ORDINANCE 19-12

**TO AMEND THE CITY OF BLOOMINGTON ZONING MAPS BY REZONING 3.85
ACRES OF PROPERTY FROM COMMERCIAL ARTERIAL (CA) TO PLANNED
UNIT DEVELOPMENT AND TO APPROVE A DISTRICT ORDINANCE AND
PRELIMINARY PLAN**

**- Re: 1800 N. Walnut Street
(CDG Acquisitions, LLC, Petitioner)**

CDG Bloomington – Revisions

JOB NUMBER
5827
 SHEET
C201
 DATE
08/22/19
 OVERALL
 SITE PLAN

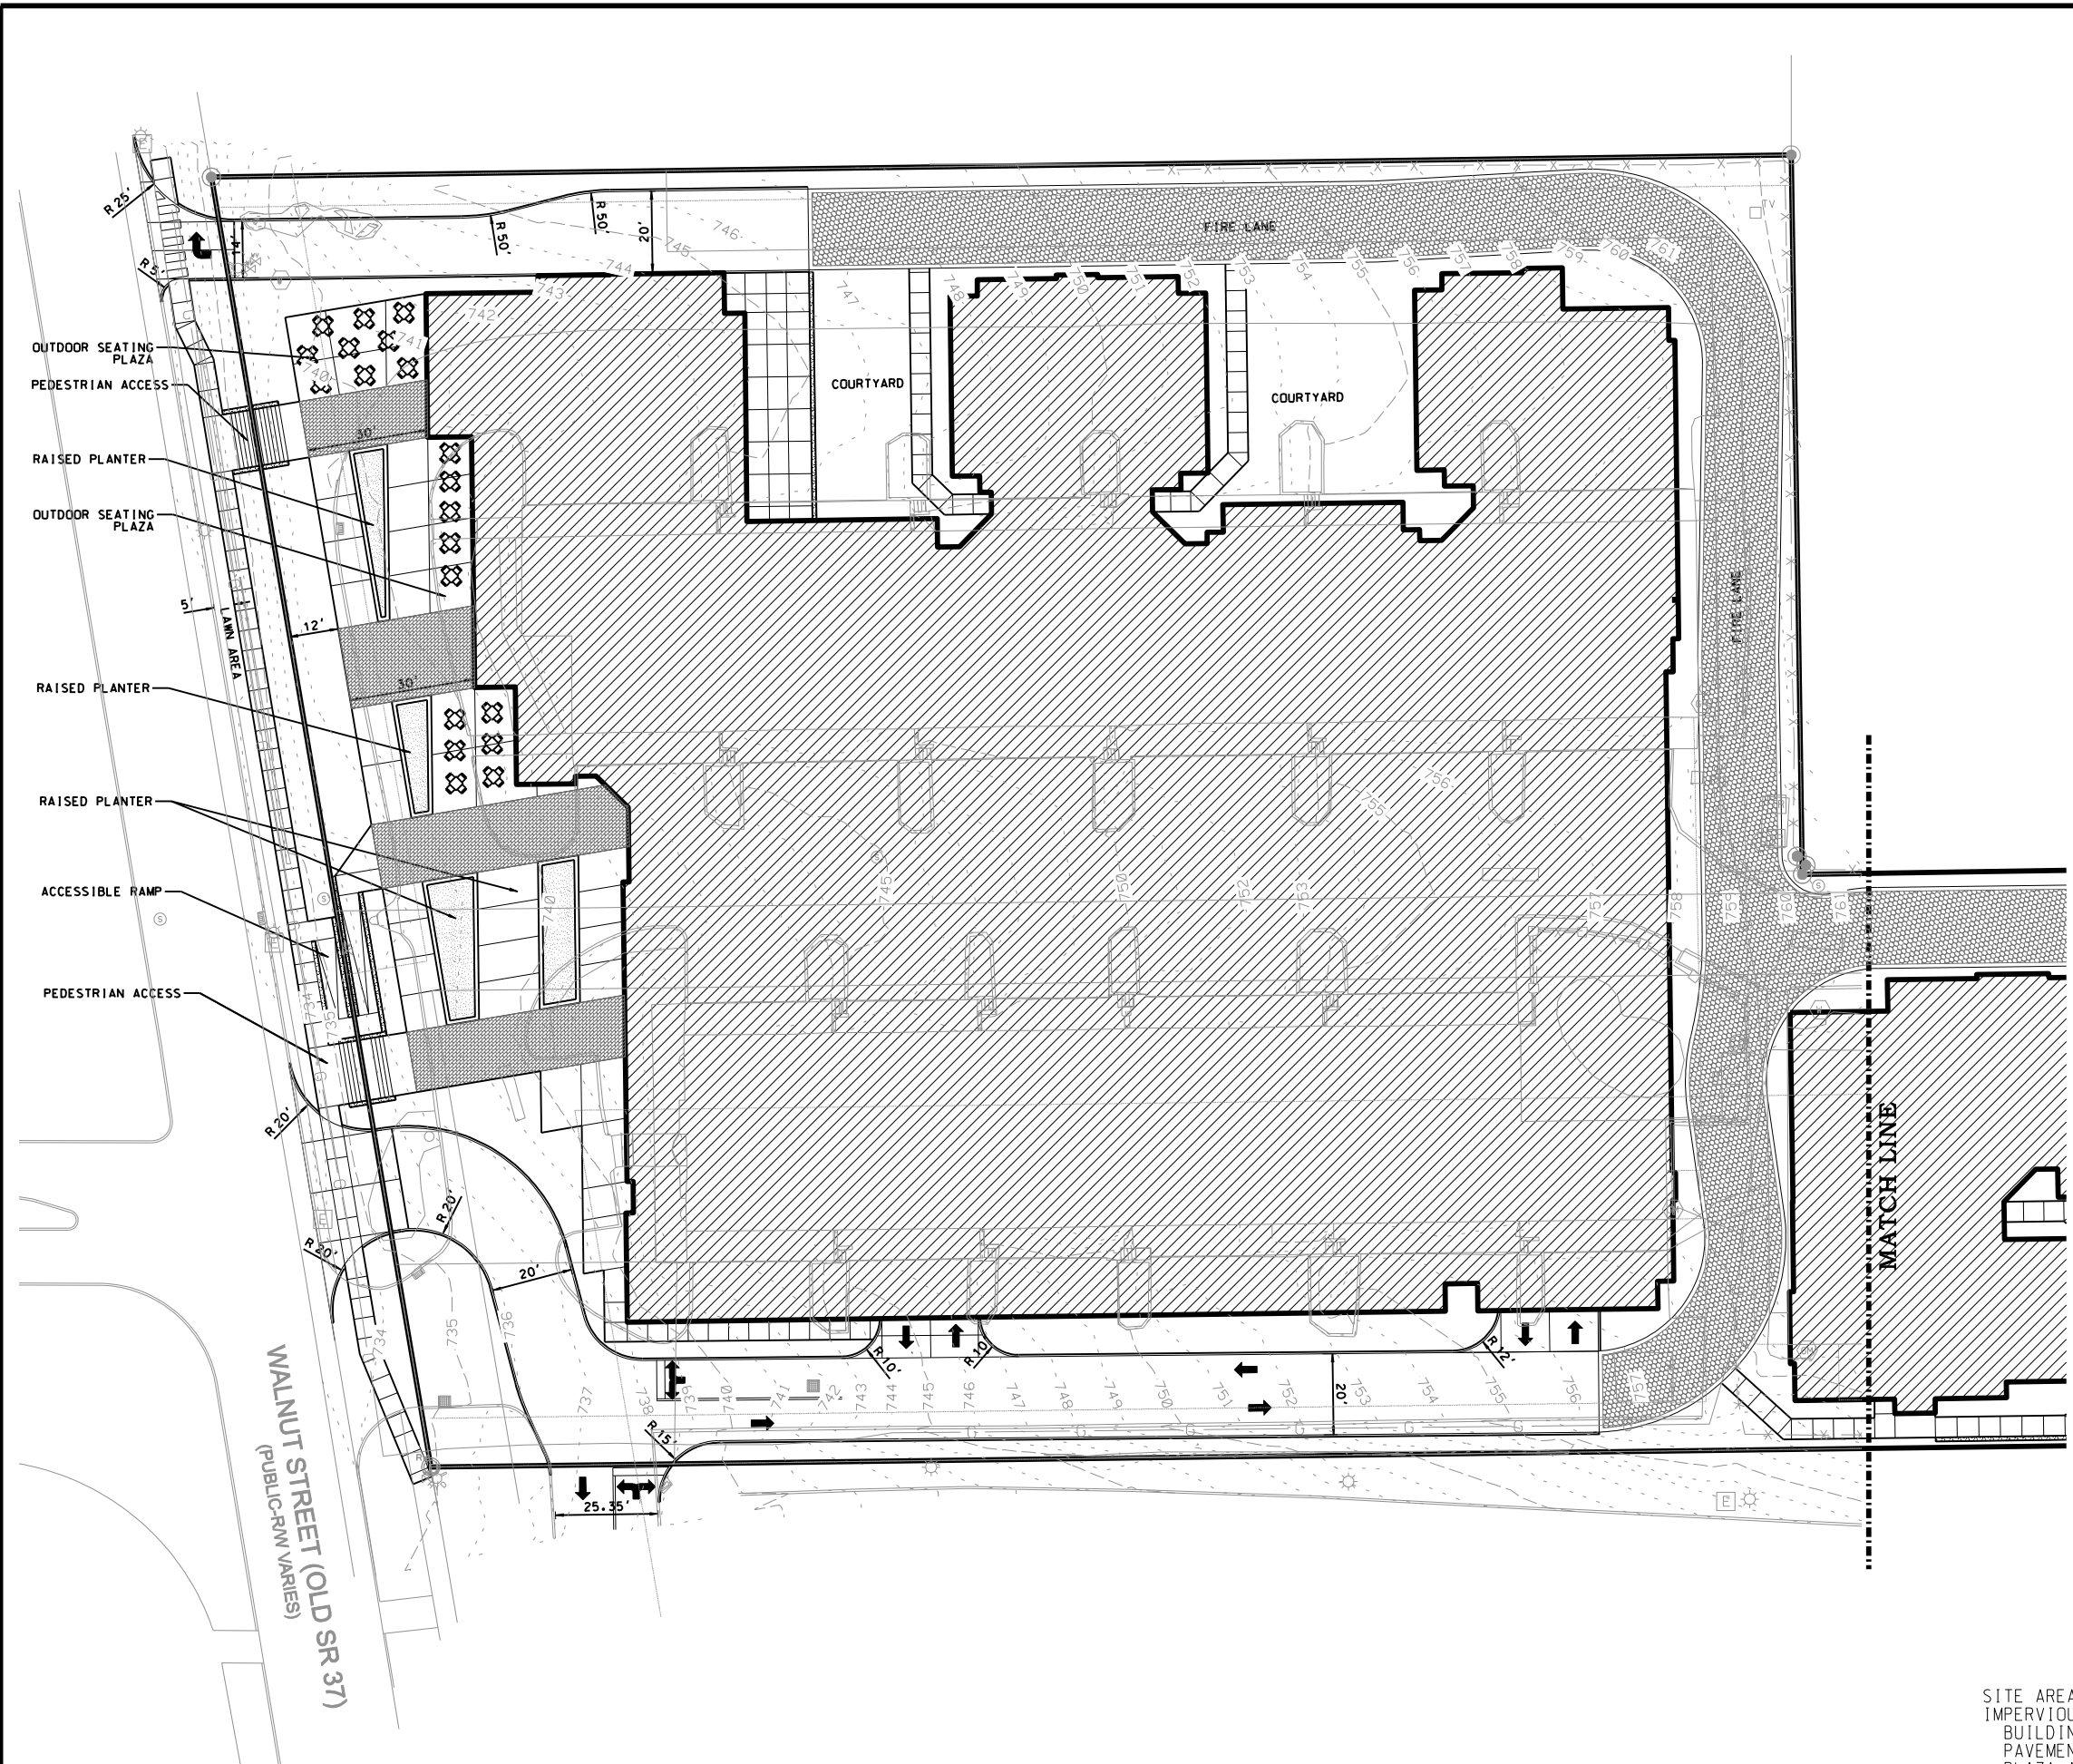
The following site and architectural revisions were made to the project to address comments received from Council and adjacent property owners:

- The access drive and parking in front of the building was eliminated. All commercial parking will be within the parking garage.
- The building was slid forward towards the public sidewalk and the commercial portion of the building was expanded to pull it closer to the sidewalk. The purpose of this was to give the building more of a street presence and to increase visibility of the commercial portion of the building for vehicles on northbound Walnut without losing visibility from southbound College. Shifting all the commercial area to the south side of the building is not feasible. The grade along the south side of the building rises so quickly that only a small portion of the space would be visible from northbound Walnut Street and much of it would be hidden behind the adjacent building and what could be developed on the adjacent site in the future. Shifting the commercial area to the south side of the building would eliminate its visibility from southbound College. Having the ability to cut through the median from southbound College to the site enforces the importance of having southbound visibility as well.

- Additional modulation was created along the frontage by sliding the building forward, adding to the front façade, creating overhang and recesses.
- A large outdoor plaza was created in front of the building with a nod towards outdoor seating and gathering to increase interaction with the street and to make it pedestrian accessible and pedestrian friendly. To make outdoor seating viable it must be separated from northbound Walnut. Walnut is a high traffic volume roadway and sitting outdoors immediately adjacent to the existing sidewalk is not desirable. Pedestrians and outdoor dining participants need to feel that their seating is safe and separate from the roadway. The noise level also needs to be low enough that conversation is possible. Having the vertical and horizontal separation shown provides that.

- Two pedestrian access points were created leading from the public sidewalk to the plaza. These access points are located at the north and south end of the plaza to promote circulation through the plaza. These access locations consist of 15' wide stairs and an accessible ramp. Both are necessary to overcome the 4' or so grade difference between the public sidewalk and plaza. The elevation difference is created by an existing water main that serves the north Walnut area that is located behind the R/W on

this site and within a 20' wide easement. The access points are accented with pavers leading towards building entry points.

- The eastern most portion of the building was shifted further north from the common property line with “The Hamptons” to create a setback of 13’-15’.
- One floor of the back building was removed, which reduced the density to 241 units and 750 beds.
- The project will include 50 solar panels, which will produce approximately 20kW of power.
- The Project will include a 2,000 SF green roof, which will provide a storm water buffer, reduce the heat island effect, reduce the energy demand and reduce carbon monoxide impact.
- CDG and Bloomington Transit agreed to preliminary terms for a public shuttle bus service. CDG will pay for the operational costs of the route for an initial term of three years.
- Additional brick was added throughout the project, including in the courtyards and along the southern façade.

1 ELEVATION FACING SOUTH
SCALE: 1"=50'

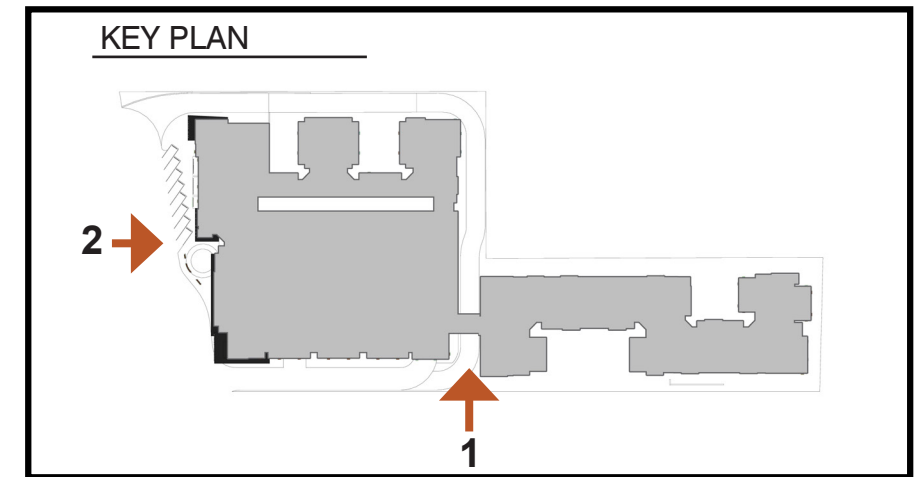
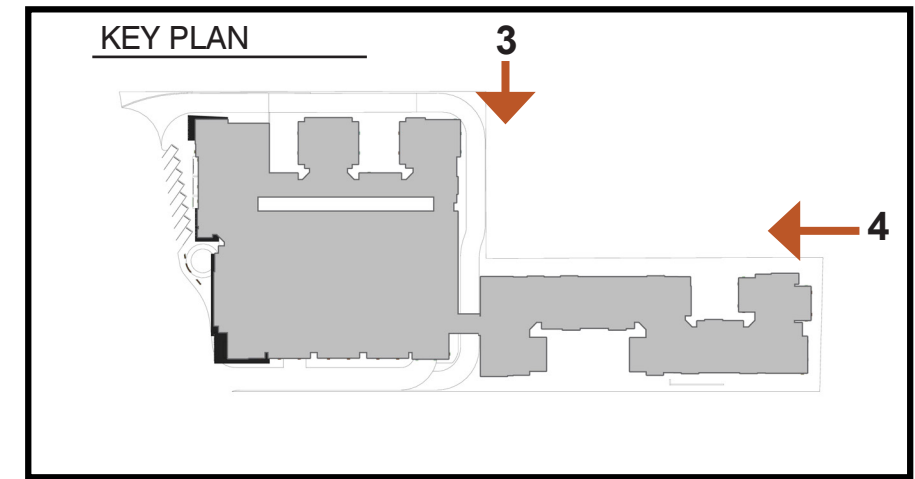
- Commit, in addition to the additional brick already committed to on the west facade, to additional brick directly above the sign marked “Seward Foundry” on both the west and south faces.
